CITY OF WESTMINSTER			
PLANNING APPLICATIONS COMMITTEE	Date 23 May 2017	Classification For General Release	
Report of Director of Planning		Ward(s) involved Bayswater	
Subject of Report	13-19 , Leinster Square, London, W2 4PR		
Proposal	Variation of condition 1 (approved plans) of planning permission and listed building consent dated 18 August 2015 (RN 15/00778/FULL and 15/00779/LBC), which sought to vary condition 1 of planning permission and listed building consent dated 22 December 2014 (RN: 14/06756/FULL and 14/06757/LBC) for extensions and alterations and the conversion of hotel to 15 flats; NAMLEY, to vary the approved drawing numbers to amend the relocation of roof terrace access stair from No. 13 to No. 14. Reconfiguration of roof plant well to bays 13 and 14. Omission of all roof lights. Introduction of raised sections of roof to bays 15 and 18 to provide additional ceiling height within penthouse units below. Enlarged glazed openings to rear terraces. Glazed roof to rear extension omitted in favour of solid roof. Glazed conservatory style wall to extensions replaced by masonry wall with single picture window set. Installation of Juliet balconies to master suites at rear l

2017 Proposed Roof Plan

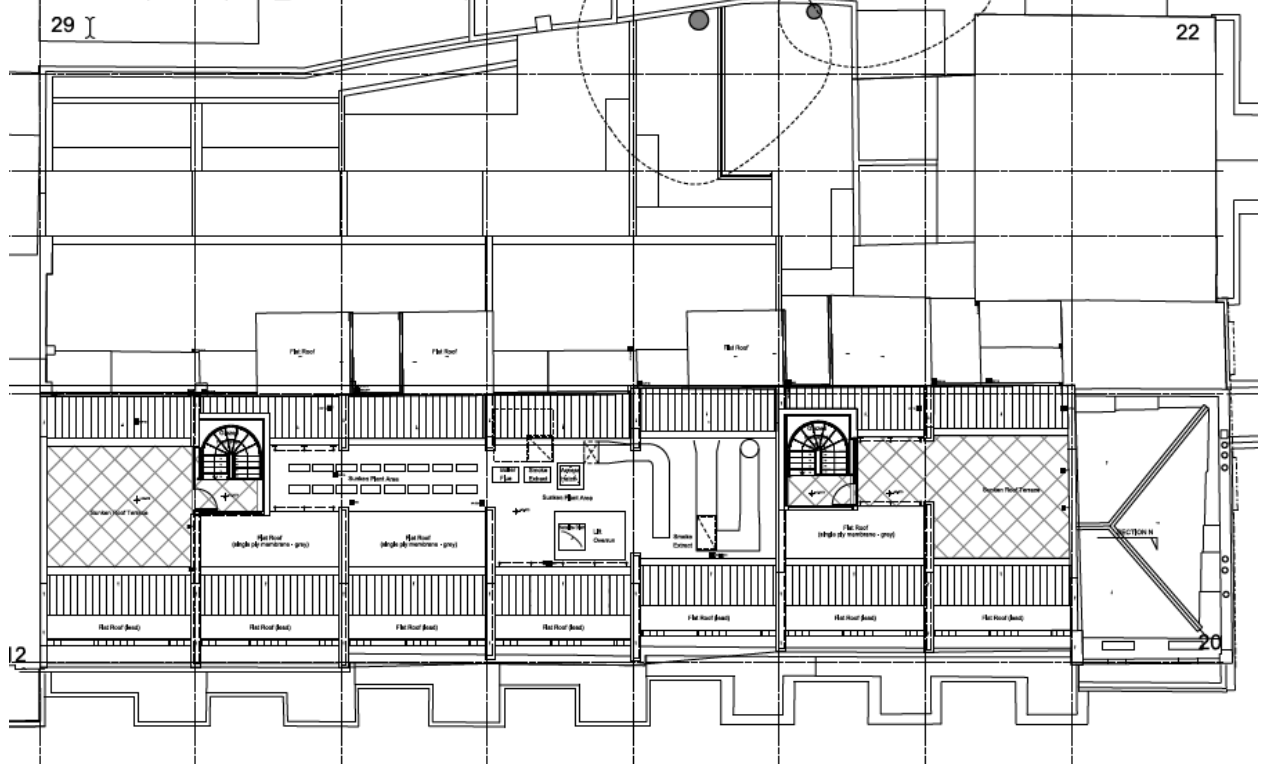
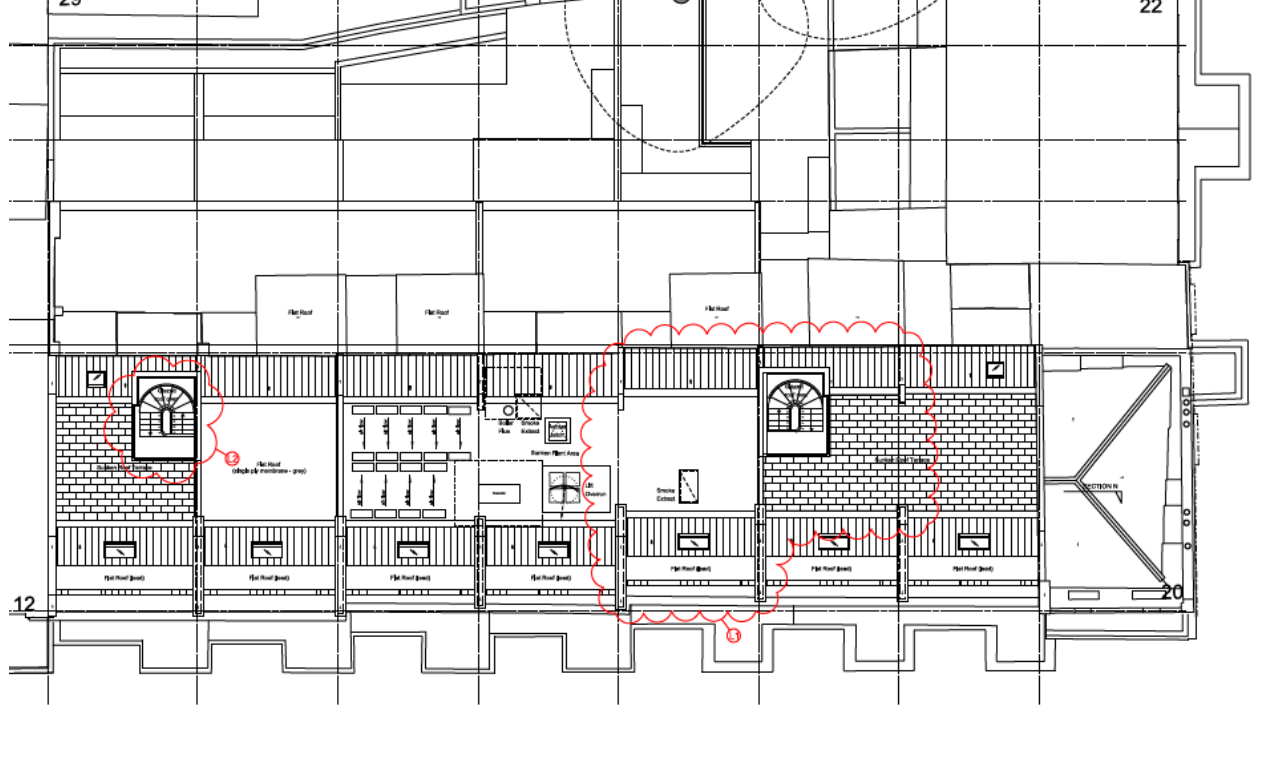
Any increase in height of roofline development will reduce light into the houses and gardens on Monmouth Road. The original consented plans show no increase in roof height.

A number of objections to the scheme relate to the change in roof height. This application proposes to relocate the roof terrace access stair from building no13 to no14, which is shown on the proposed section C-C. There is no change in the height of the roof apart from the introduction of the glazed access enclosure to no14. The introduction of 2no glazed enclosures was considered under the previous applications and given the mansard is a later addition to the building and the limited visibility of the enclosures in oblique views due to the height party wall upstands they were considered to be acceptable. As the enclosure will be located against the inside of a party wall upstand on a building which sits within the terrace, the proposed location is considered to reduce the visibility further.

Additional alterations at roof level include the reorganisation of plant and the removal of rooflights. As the plant will occupy the same area and will not project above the parapet, this alteration is considered to be limited. The omission of the rooflights is welcomed as it will remove high level clutter and maintain an uninterrupted roof form.
